Port of San Francisco
Joint meeting of the
Port of San Francisco
Waterfront Design Advisory Committee
and
Bay Conservation and Development Commission
Design Advisory Committee

Staff Report

Meeting Date: May 5, 2014 – 6:00PM

Re: **Pier 70 Crane Cove Park Master Plan (“Park Master Plan”)**
(see: sfport.com/cranecovepark)

CRANE PLAZA SLIPWAY STEPS: THREE DIMENSIONAL VIEWS

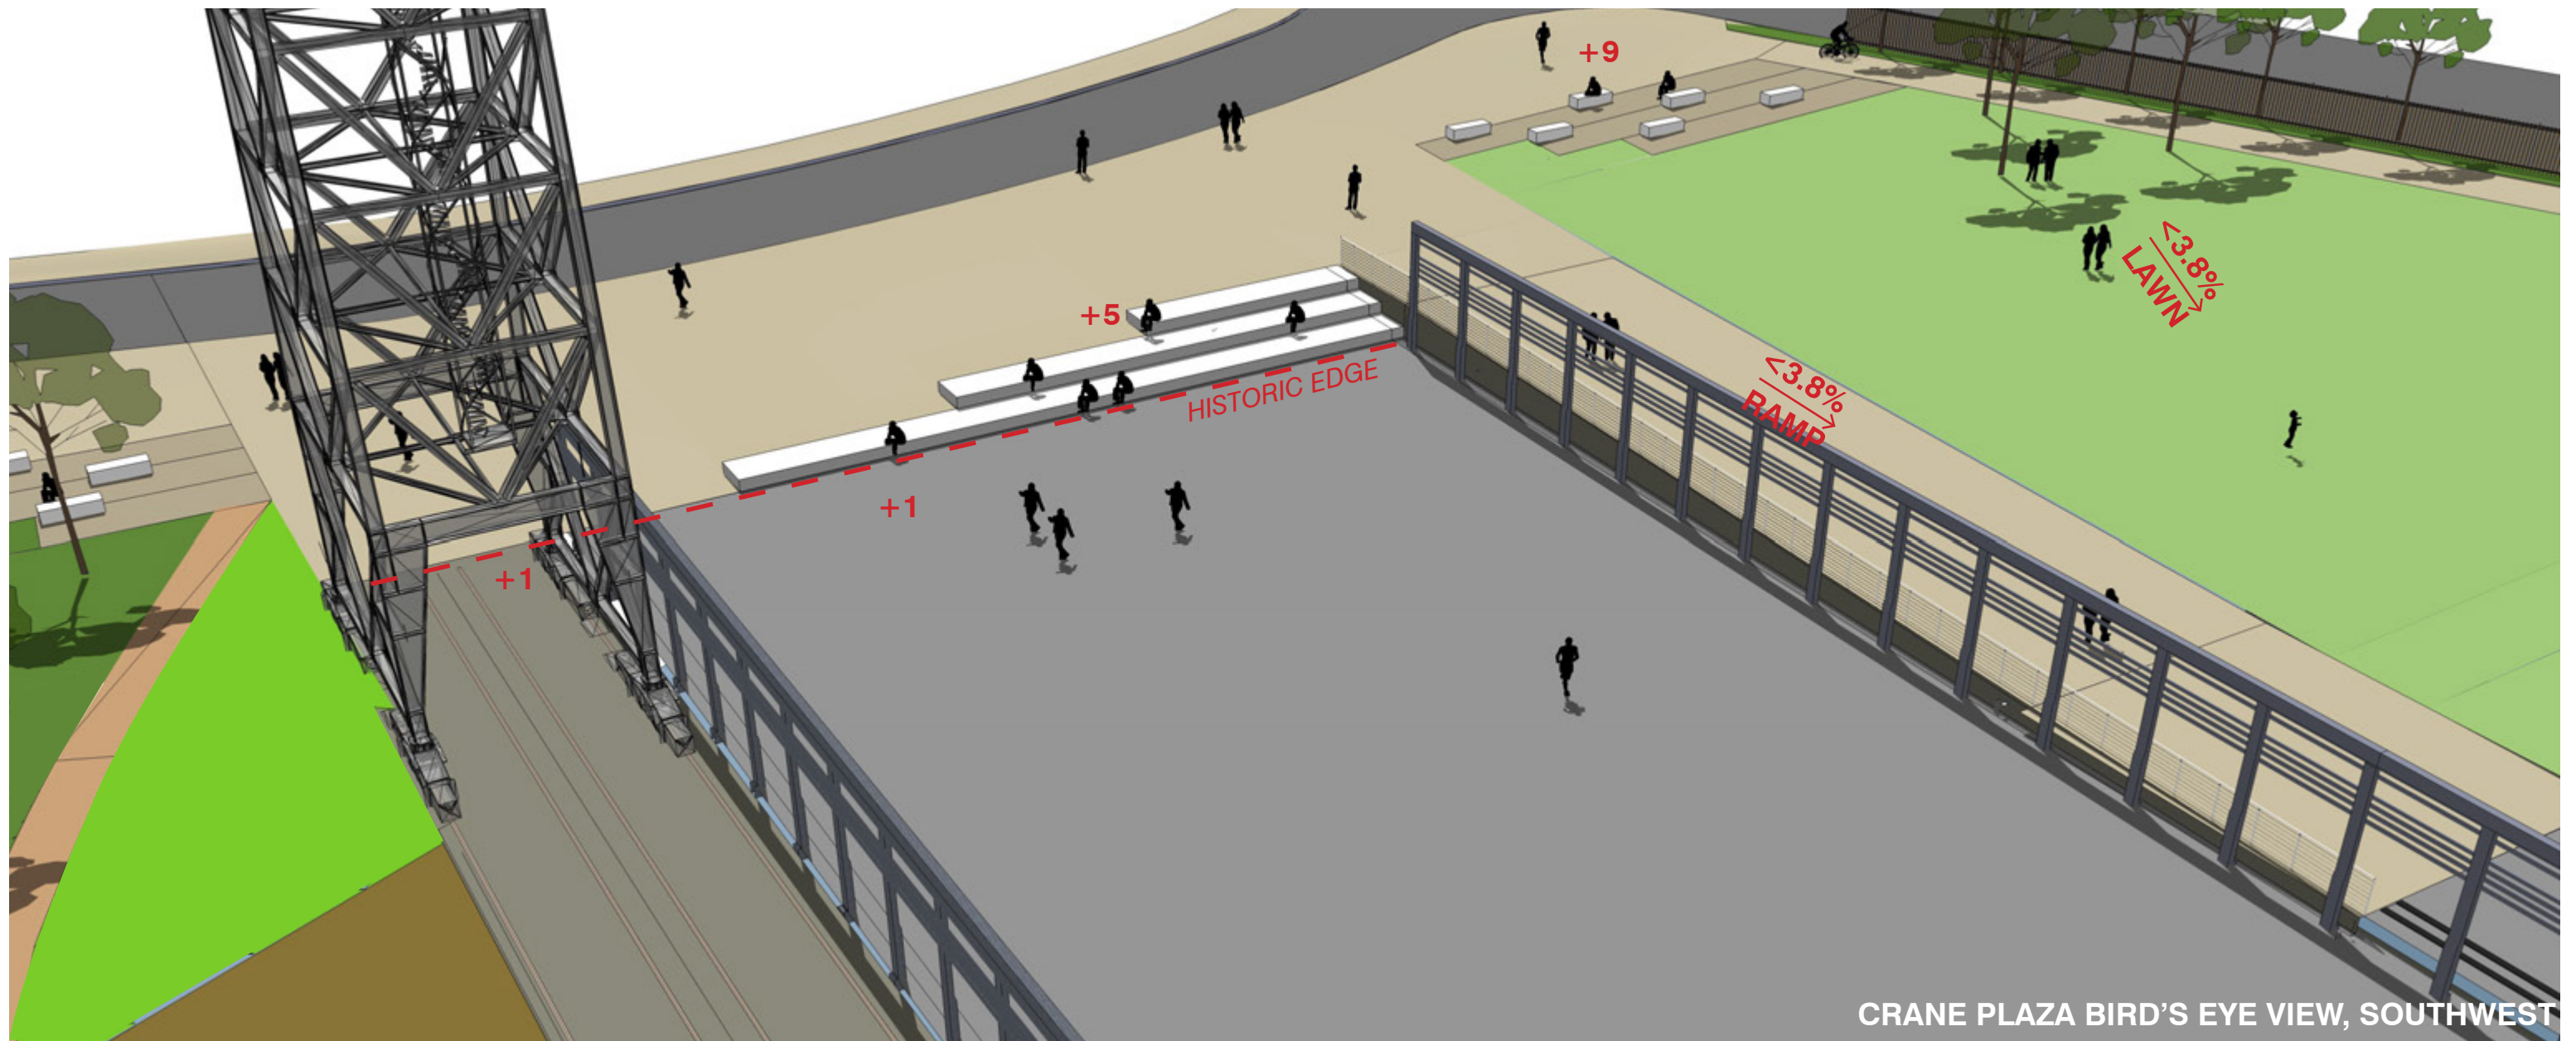
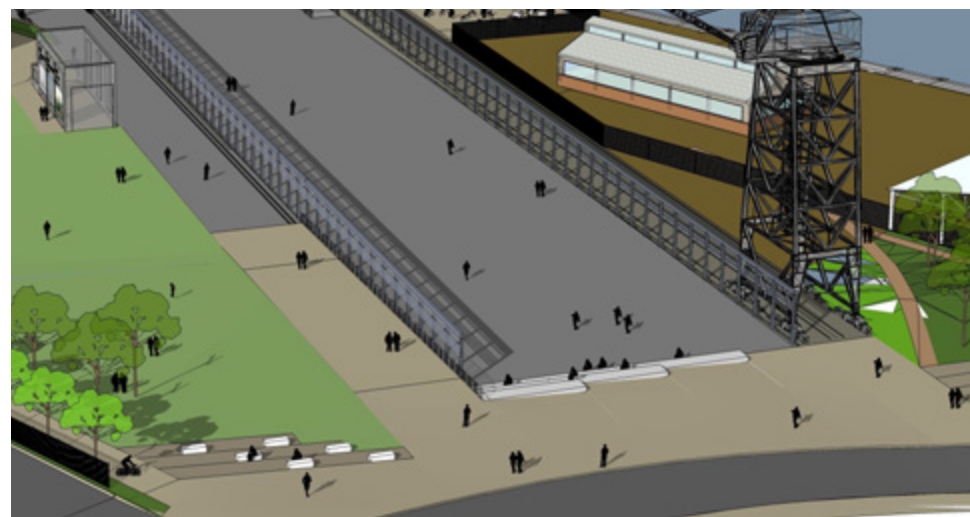
- a) Concern was raised about the narrowness of the 19th street sidewalk and the lack of gathering space within the plaza
- b) Requested further analysis about how lawn area meets 19th and Illinois Street
- c) Suggested that if Illinois Street fence be moved, it should be considered in the context with the existing portion south of 19th street

2. Slipway Seating Steps (see Exhibit 8 & 9, Slipway Seating Steps)

This concept utilizes a series of terraced seating steps into the slipway, which are also located outside the existing slipway footprint and serves as an arrival and termination to the slipway. The design profile for 19th Street in this concept is a more natural continual slope east of Illinois Street, which allows the seating steps to terminate before the eastern side of the “Ways”. The plaza is flanked by a series of seating steps on its western corner that will function as an amphitheater and seating area facing the

shipyard and the cove, where large and small public events can occur. This concept requires less fill at the end of the slipway, allows the user to recognize and distinguish the original form and function of the slipway, provides for universal access into the slipway from the south end and provides more flexibility for access into the slipway. Materials considered for this approach are the same as those described in the Formal Seating Steps alternative, except the seating and steps of Crane Plaza will utilize a concrete material but with a distinct concrete color and finish from that of the historic slipway and use a cobble paving band along the south edge of the seating steps to serve as a transition between the plaza and the seating steps.

In this alternative, the entrance to the park at 19th and Illinois Street includes a paving pattern that matches the seating steps with raised seat walls with direct access into the Open Green
